Viking CCS Pipeline

9.75 Stage 1 Road Safety Audit for Access Points 11AA, 11AB, 12AA, and 13 AA

Document Reference: EN070008/EXAM/9.75

IMAGE: Extract from 60718962-ACM-GEN-ZZ-DR-CH-0005 showing swept path analysis for Access 13AA.

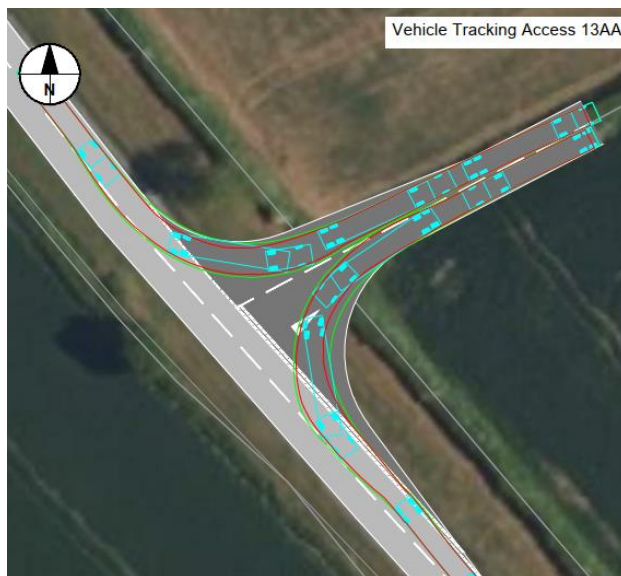
Drawing 60718962-ACM-GEN-ZZ-DR-CH-0006 shows the proposed junction design for Access 13AA off the A18. As part of the design information issued to the Audit Team, swept path analysis has also been provided.

The Audit Team has concerns that southbound vehicles entering the construction access are required to enter the northbound lane to undertake the manoeuvre. Should this occur, there may be an increased risk in head on type collisions between southbound vehicles entering Access 13AA and vehicles traveling northbound on the A18.

It is recommended that the junction geometry is changed so that turning movements can be made without vehicles encroaching on the opposing carriageway lane.
